Demand Response Barriers Study

DECK WITH STAKEHOLDER COMMENTS

Demand Response Barriers Study

California Background and DR Barriers

Demand Response Funding Flow Chart

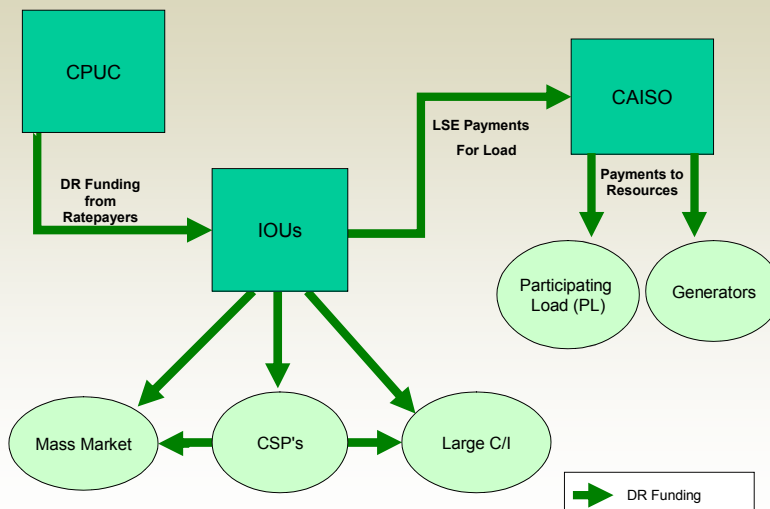
Slide 10: This graphic of the “funding” for demand response misses the “avoided cost” nature of demand response programs. While the IOU participation payments are “funded” from ratepayers, what is missing from this graphic is the reduction in resource adequacy costs incurred by IOUs as a result of procuring demand response. Also, the arrow labeled “LSE payments for load” should actually be “LSE reduced payments for energy” with the direction reversed.

Enrolled¹ MWs in Utility Demand Response Programs

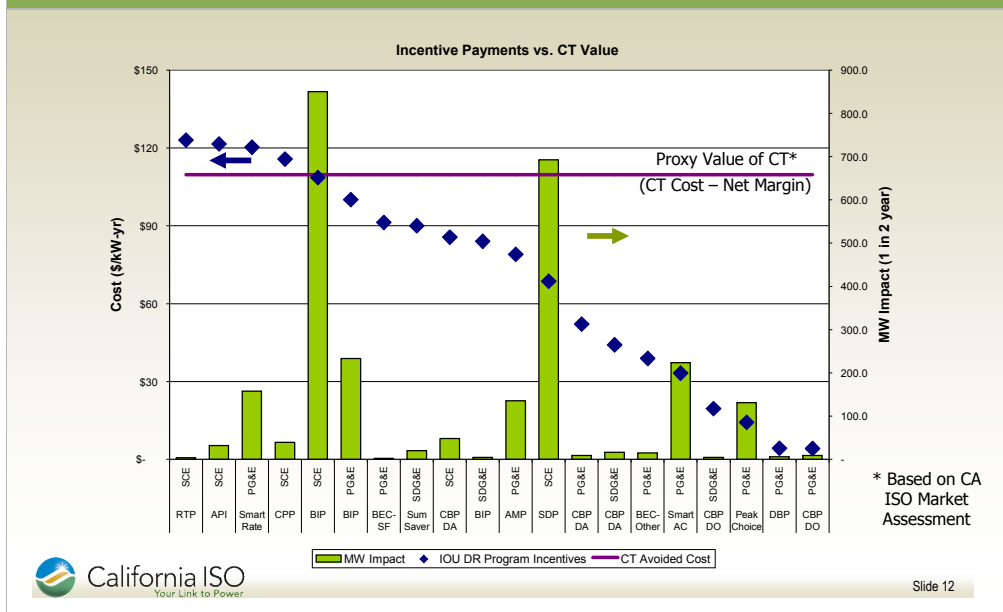
Slide 11: This chart is no longer accurate and should be updated, revised or eliminated. Regarding the quantification of 1,850 MW of "emergency-triggered programs", SCE believes that it has resolved the CAISO's concern with reliance on emergency-triggered programs by changing the trigger point of the BIP program to prior to when an emergency is declared. (A similar change to the SCE's other reliability programs (i.e. Agricultural Pumping and Air Conditioning Cycling, a.k.a. Summer Discount Plan, are pending approval.) There is a similar statement on Slide 19 that also requires correction. Also, the reference to a 5% goal as a price-responsive goal has been withdrawn by the CPUC pending reconsideration. In the proceeding considering Applications A.05-06-006, et al, Commissioner Chong issued a proposed decision explaining that revisions to the 5% price responsive goal were necessary. Subsequently, the Commission initiated rulemaking R.07-01-041 to address DR goals, cost effectiveness and other issues. DR goals are to be addressed in a pending decision under Phase II.

Proposed IOU Incentive Payments and Impact in 2009-2011 Program Plans

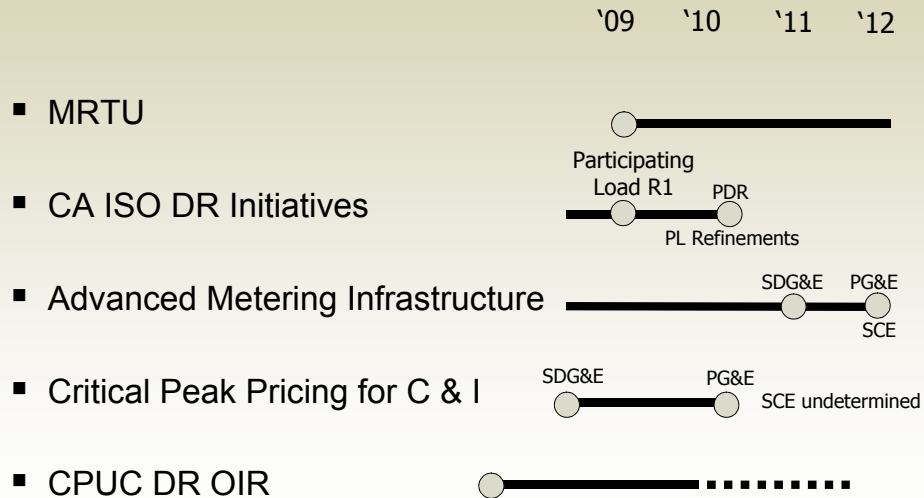
Slide 12: The graphic on the slide is misleading and provides no value. It also does not include SCE's entire proposed portfolio (e.g. DBP, CBP Day-of, and DR Contracts). Moreover, the incentives listed do not show any correlation to the MW impacts. In fact, RTP does not have incentives but rather increased prices due to weather conditions. Lastly, the slide does not prove whether or not a program is beneficial and should be adopted by the Commission.
